Case #: ZBA 2012-83
Date: October 11, 2012
Recommendation: Conditional Approval

PLANNING STAFF REPORT

Site: 219-221 Elm St, a/k/a 387-391 Summer St and 217 Elm St, a/k/a 376 Summer St

Legal Notice: Applicant Painted Burro, Inc. and Owner Laverty Family Trust, seek a Special Permit with Design Review under SZO 7.11.10.1.1.c to establish a restaurant use between 5,000 and 9,999 gross square feet and a Special Permit under SZO §4.4.1 to modify the storefront, including window openings, of the existing nonconforming structure. CBD zone. Ward 6.

Existing Conditions

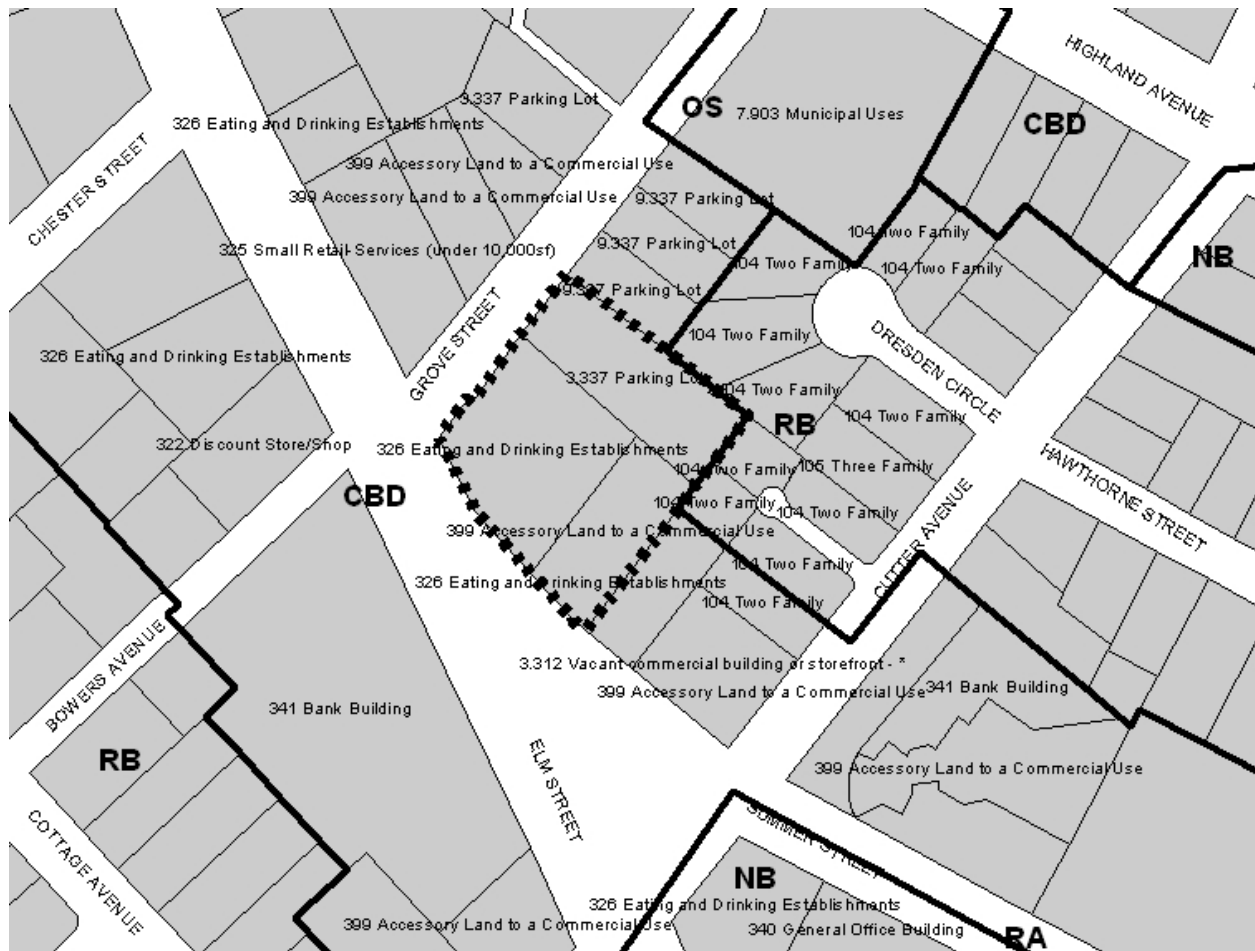
HPC Staff finds that the proposed alteration to the fenestration and signage will not significantly alter the original fabric of the building.
